828 MLK Blvd.

Plan Comments/Notes

Prepared by: Brian Peterson, AIA, Urban Designer, TOCH

From 3-11-22 meeting with the applicant team, notes prepared 3-14-22

Fig. 1: Reviewed Site Plan Concept

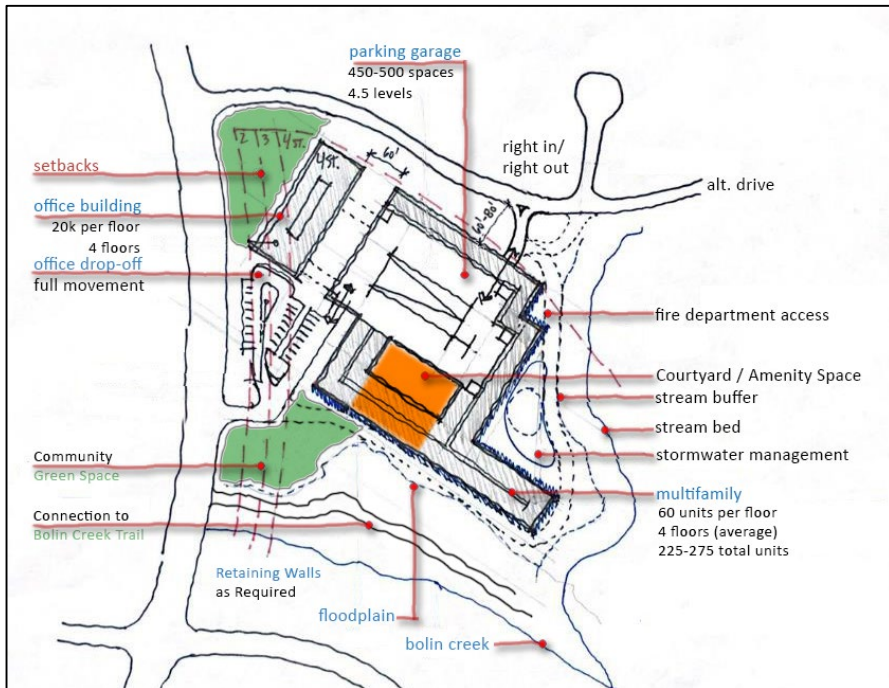
A design review meeting was held with the applicant team to discuss their current site plan (see attached Fig. 1). In advance, I had prepared a sketch (see attached Fig. 2) with some suggested modifications and design comments which served as a point of discussion for the meeting.

1. In order to enhance its street presence, consider rotating the office building to be parallel to the MLK street frontage. This can help break down the mass of the building complex. The building could be 3 stories along the street frontage, and step up to 4 toward the rear. The front of the building could have a more urban landscape, perhaps with a double row of trees. Applicant team was open to looking at this idea.

2. Consider placing any surface parking in a "parking court" between the office building and the parking structure. Additional surface parking could be provided as parallel parking along the entrance drive, which should be designed with an urban streetscape character. This would free up more of the front part of the site to utilize as green space.

4. If there is to be a parking lot area in front of the building, it could be small, and designed to look and function as a plaza-like space for occasional events, such as food trucks.

Fig. 2: B.P. Plan Comments

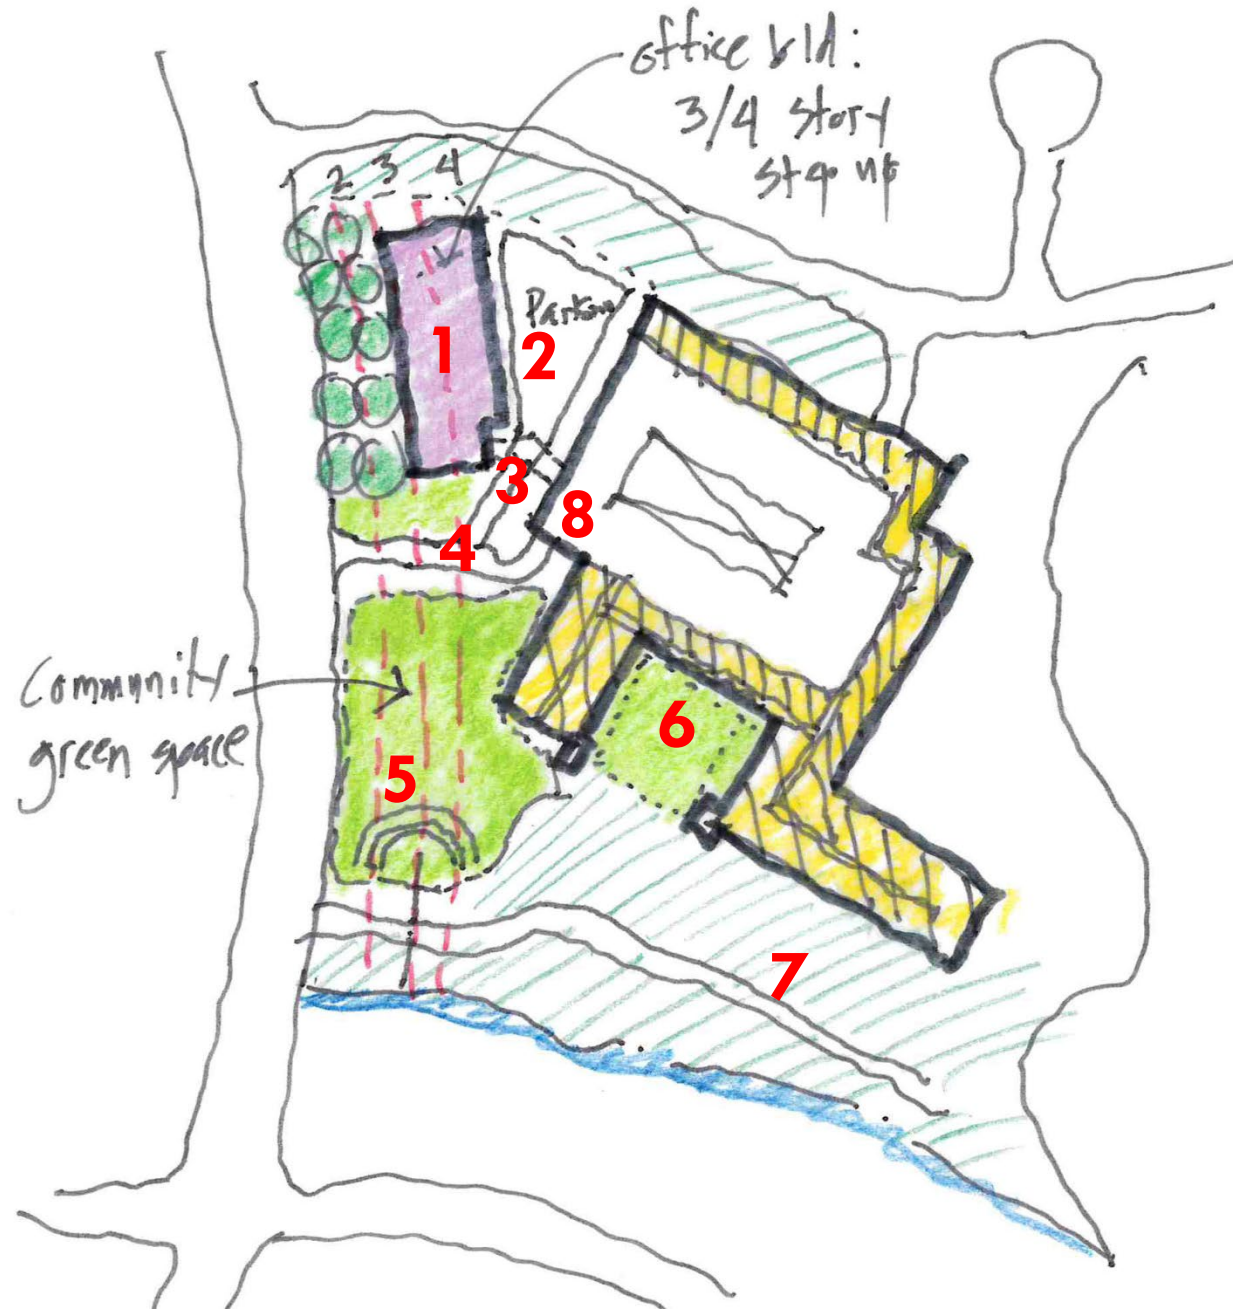
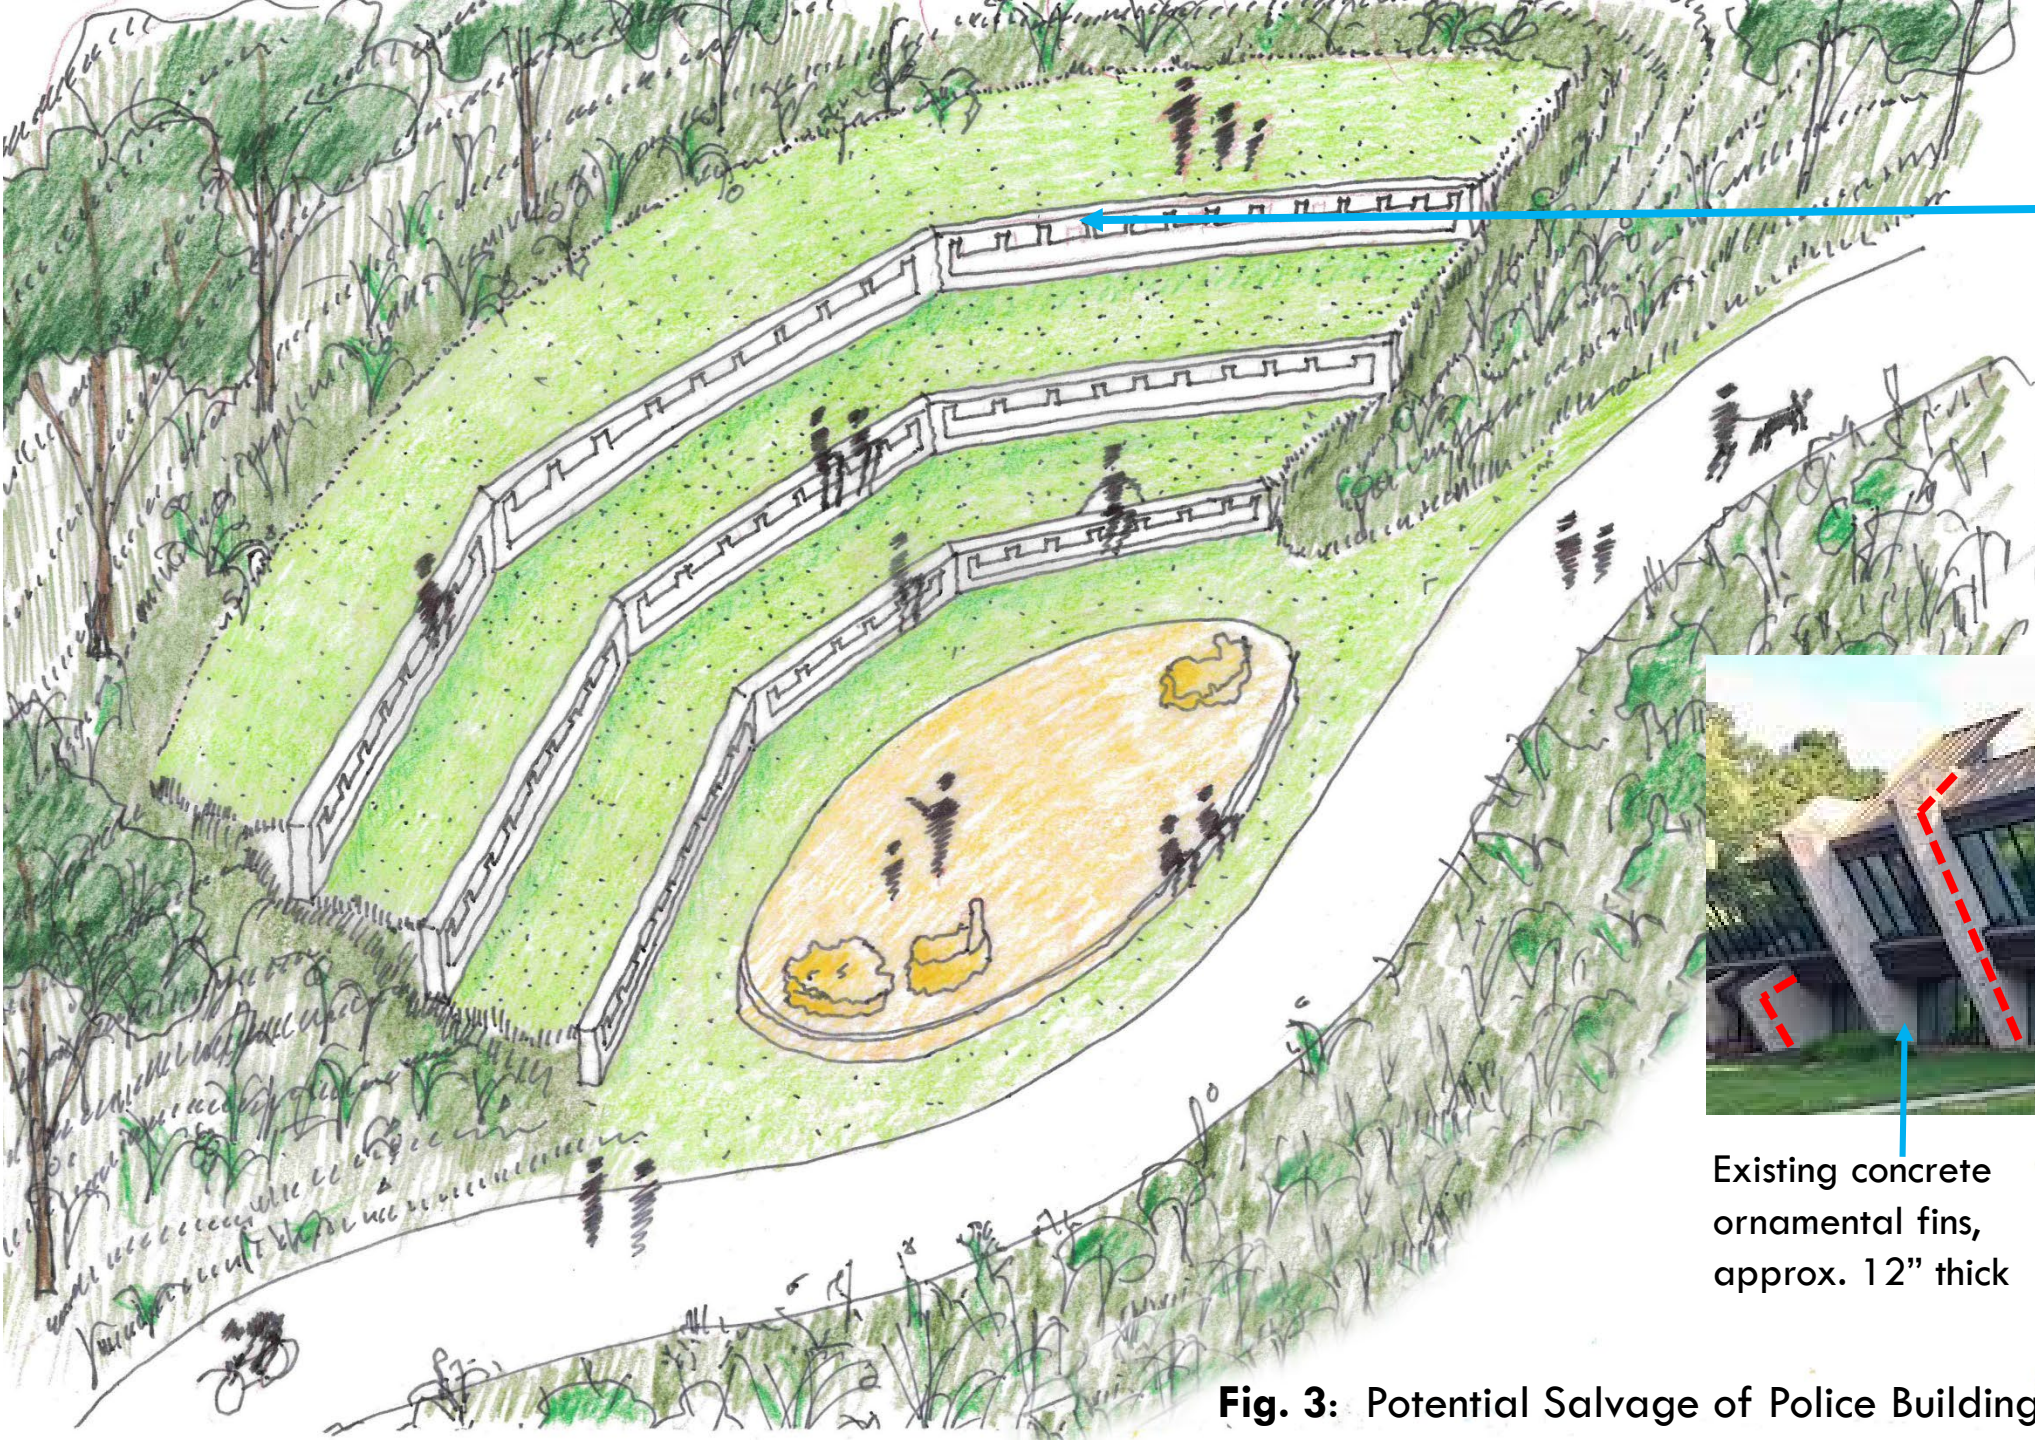
3. Also discussed the possibility of utilizing the site's level changes to provide an upper level terrace space to connect the parking garage and the 2nd floor of the office building, which could be where the main lobby would be for the main public facilities in the building.

6. Consider creating a courtyard on the south façade of the multifamily building, opening out to face the creek side natural corridor. The applicant noted that this idea was already being considered.

7. Slope down to creek/retaining walls: retaining walls could be done in various ways. One possibility suggested was to consider using a system of large blocks that look like stones with integral planters, similar to that utilized to the west, along the Bolin Creek trail and Tanyard Branch. In general the design of landscape, engineering features, and site details along the creek side of the property should be selected with a goal of integration and enhancing the character of the trail.

8. Exposed sides of parking garage: should be designed with architectural screening, to integrate with the architectural character of the other buildings.

Fig. 3: Potential Salvage of Police Building Concrete Ornamental Fins

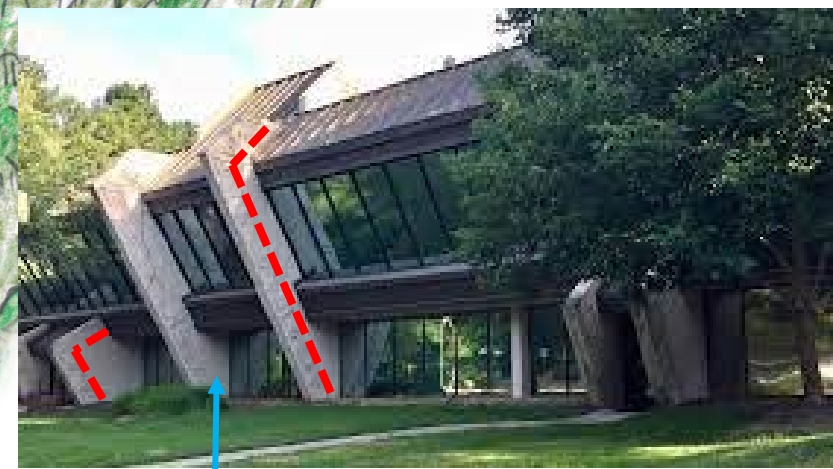
5. The community green space was discussed: the space is envisioned to feature mostly passive use, with the possibility of having occasional events and small gatherings. One possible gathering space could be a small stepped amphitheater-type space, for which I prepared a sketch (Fig. 3). The stepped walls could potentially be constructed with some of the ornamental concrete "fins" salvaged from the existing police building. This salvage concept will need to be studied both in terms of feasibility and cost as the design of the project progresses. The amphitheater space is seen as not so much as a place for large gatherings or performances but for small informal events. The idea would be to make the community green space a series of connected places leading up from the Bolin Creek trail to the new municipal building.

Potential Re-Use: utilize panels as retaining walls (or as facing on poured-in-place foundation walls) to create an outdoor amphitheater/gathering area. *Note: the feasibility and cost of this salvage will need to be studied as part of the design process*

Existing concrete ornamental fins, approx. 12" thick
